**EXHIBIT LIST FOR SUB 2019-003/EA 2019-015
Preliminary Plat of Steeplechase**

STAFF REPORT TO THE BENTON COUNTY PLANNING COMMISSION

FILE NO: **SUB 2019-003 (Preliminary Plat- Steeplechase)**

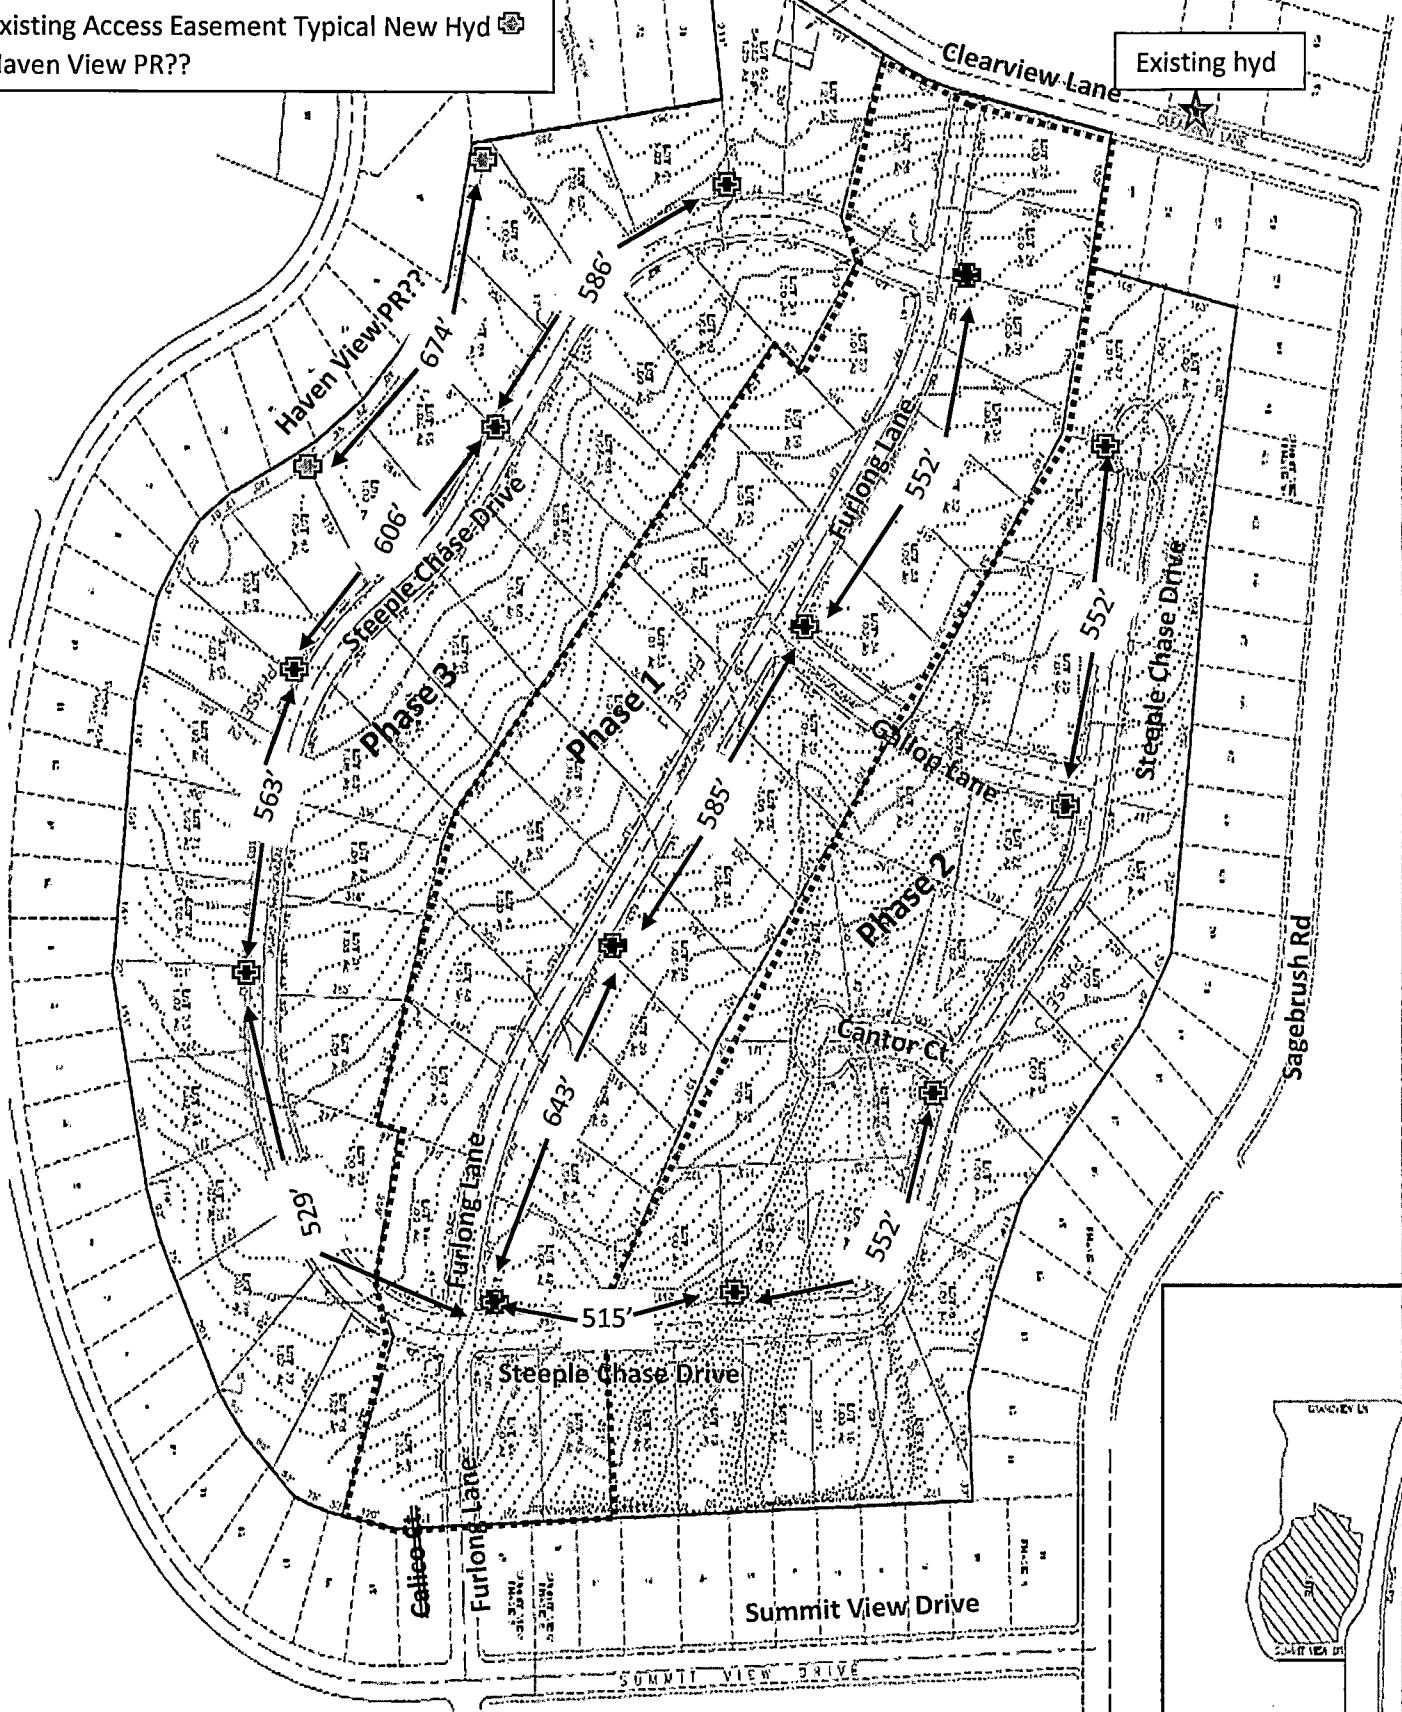
1. Calico Court will need to be renamed Furlong Lane (see attached site plan pg.2).
2. Hydrants have been placed for all three phases.
3. Clarification is required for Phase 3. Along its southern border, a cul-de-sac is shown extending from Lot 63 to Lot 68. The modified attached site plan identifies this as an existing cul-de-sac that I guessed might be "Haven View PR?"

- c. Should this be Haven View PR and it is intended to serve Steeple Chase phase 3's lots 63 to Lot 68 as well as the current lots of Summit View 6 & 11, the PR will need to be 20' wide, and hydrants placed as shown on the attached site plan (pg 2).

- d. Should this be a new proposed cul-de-sac for the Steeplechase plat, the site plan must be corrected to show the entry point of the road serving the new cul-de-sac and the road's width.

R-11

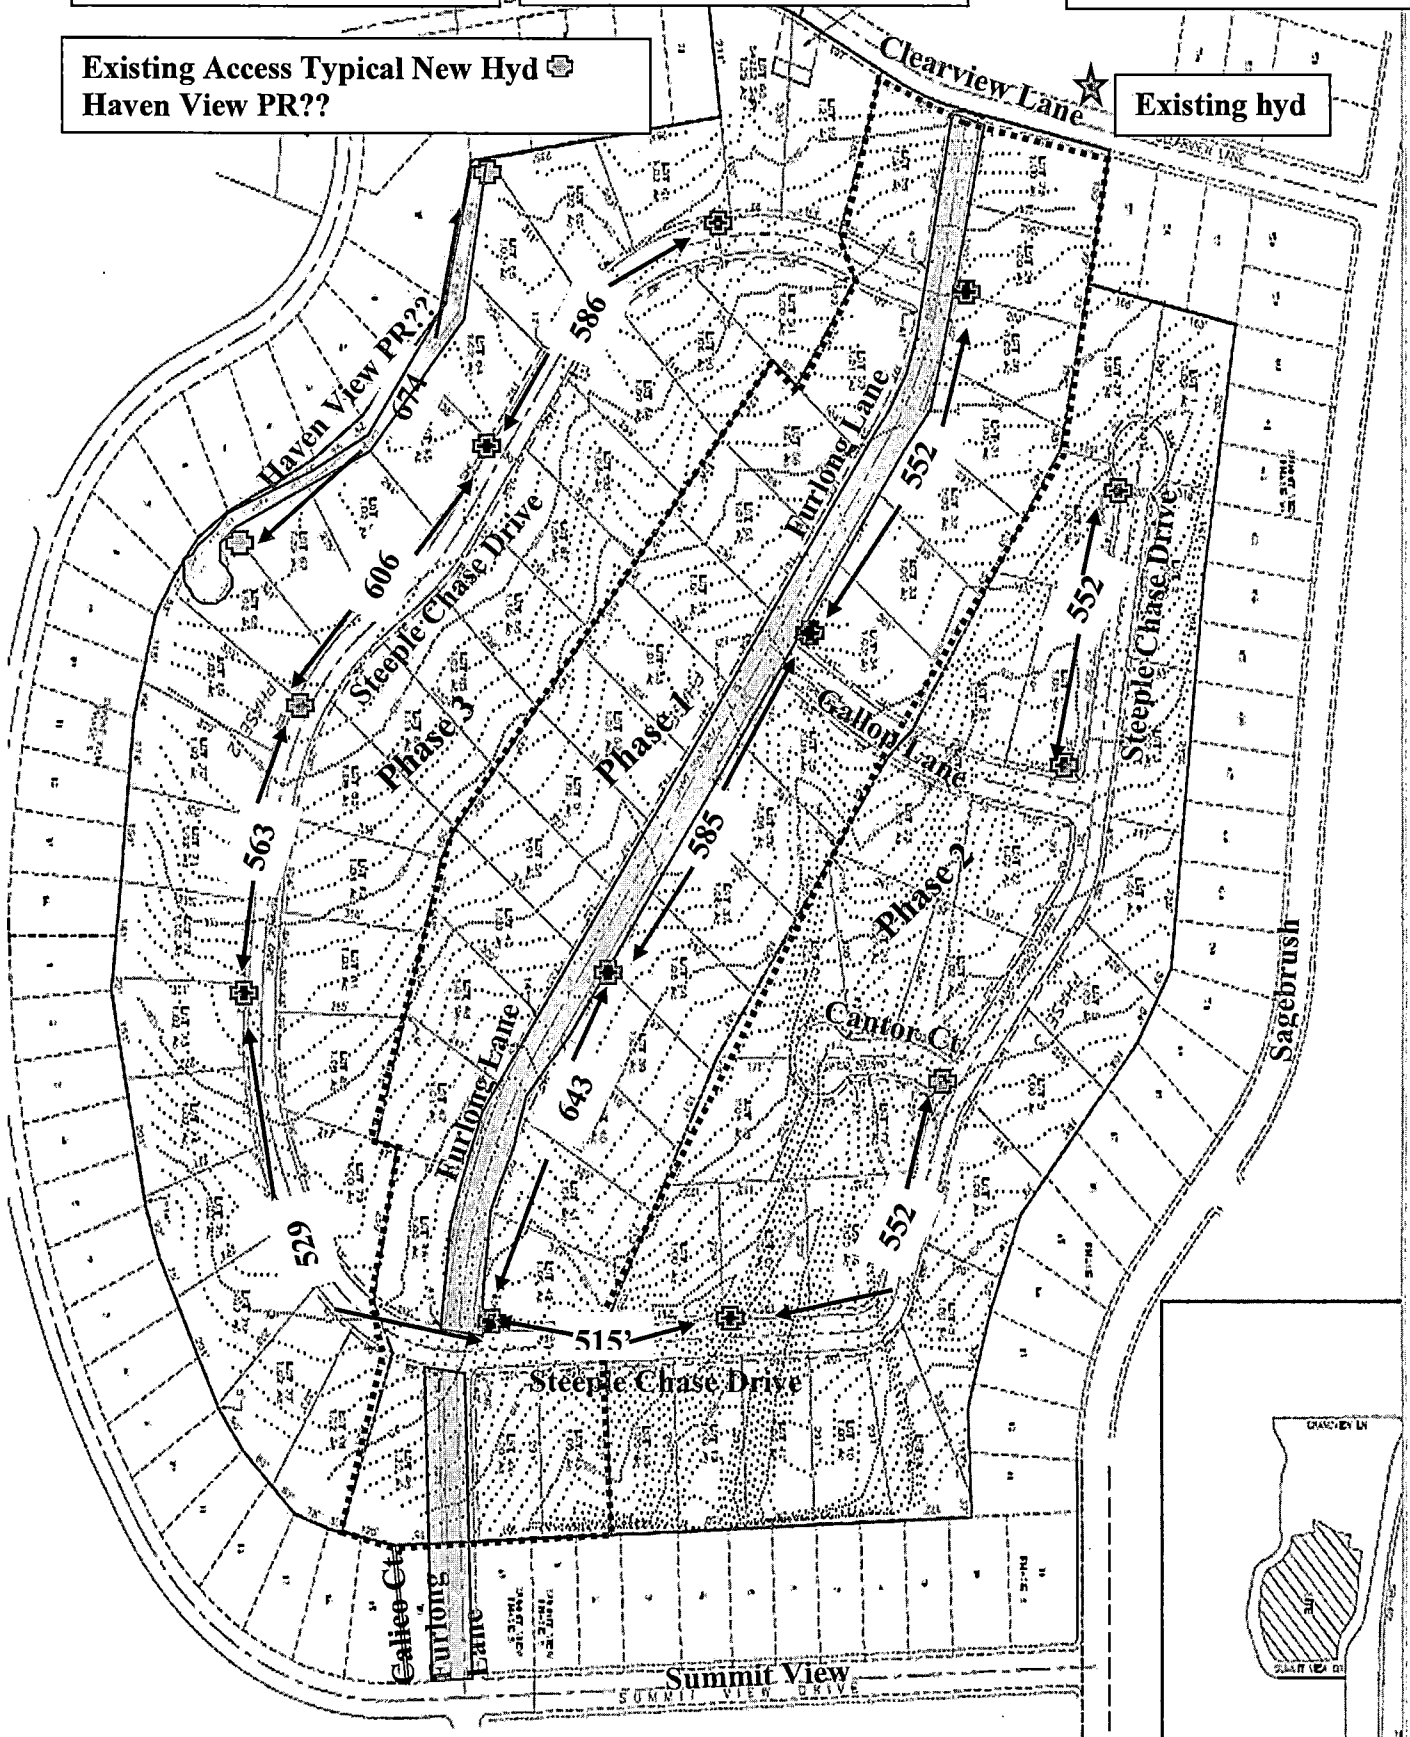
1. Calico Court will need to be renamed Furlong Lane (see attached site plan pg.5).
2. Hydrants have been placed for all three phases.
3. Clarification is required for Phase 3. Along its southern border, a cul-de-sac is shown extending from Lot 63 to Lot 68. The modified attached site plan identifies this as an existing cul-de-sac that I guessed might be "Haven View PR??"

- a. If this is not Haven View but is a new PR, two hydrants have been spaced along its length.
 - b. It must be clarified whether or not this "existing" cul-de-sac is Haven View PR or not.

- c. Should this be Haven View PR and it is intended to serve Steeple Chase phase 3's lots 63 to Lot 68 as well as the current lots of Summit View 6 & 11, the PR will need to be 20' wide, and hydrants placed as shown on the attached site plan (pg 5).

- d. Should this be a new proposed cul-de-sac for the Steeplechase plat, the site plan must be corrected to show the entry point of the road serving the new cul-de-sac and the road's width.
